**TITLE: Proposed Changes To MIL-PRF-38535 Requirement
Of
Laser Scribing For Die Separation From Wafer.**

EP Study Project Number: 5962-2014-007

FINAL REPORT

Fig: 1 Laser grooving and dicing with diamond saw. Fig: 2 Laser grooving prior to dicing

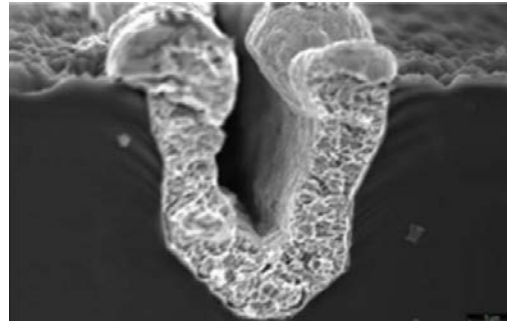
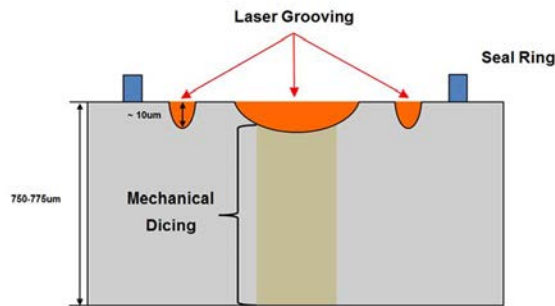
During JEDEC JC-13.2/G-12 meeting, some manufacturers also informed that they used both laser saw and diamond saw wherein start grooving by laser saw and then use diamond saw for die separation.
